# SERVICE BULLETIN

Classification: EC00-024b	Reference: NTB00-070b	Date: June 7, 2004
------------------------------	--------------------------	-----------------------

## 2000-2001 MAXIMA MIL "ON" WITH DTC P0420 STORED – THREE WAY CATALYST FUNCTION

**APPLIED VEHICLES:** 2000-2001 Maxima (A33) - Except 2000 Maximas with Federal Emissions Specification

Figure 7

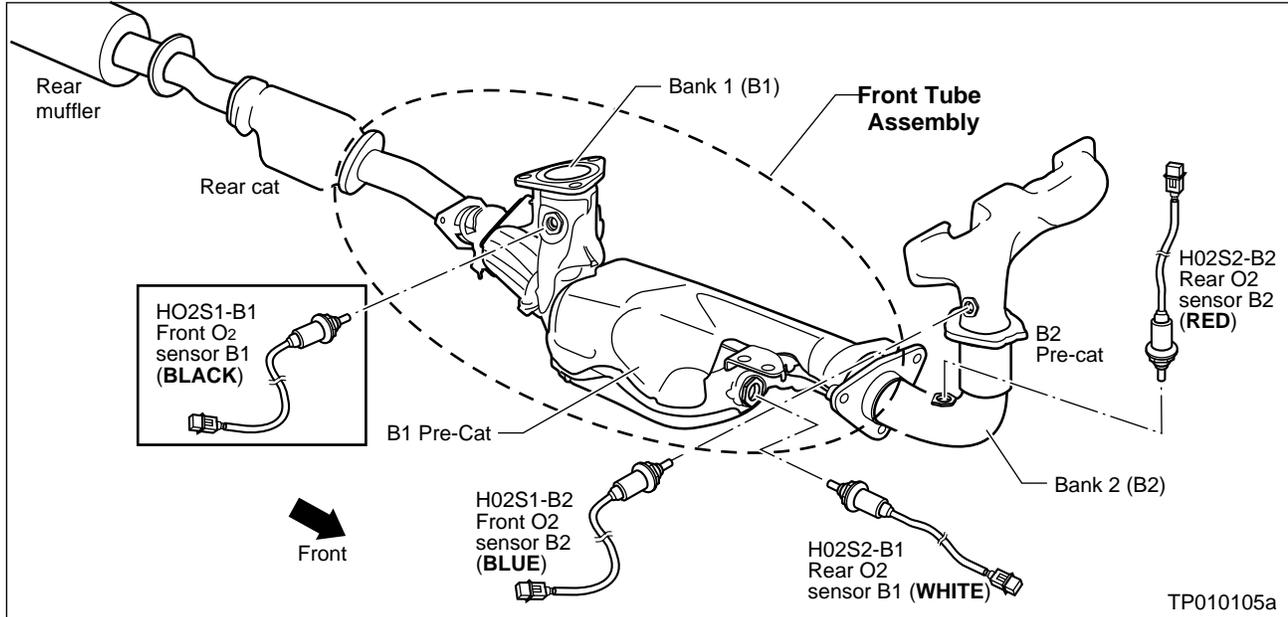
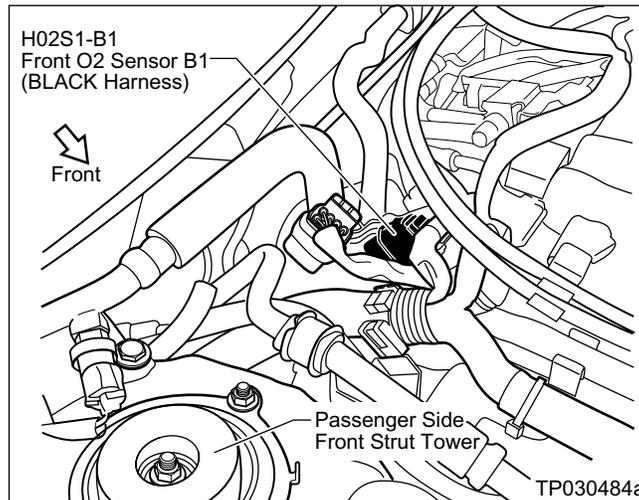
Replace the Front Tube Assembly and the Front H02S1-B1 Oxygen Sensor (see Figures 7 and 8 below).

- Refer to the **FE** section in the applicable ESM for the replacement procedures.
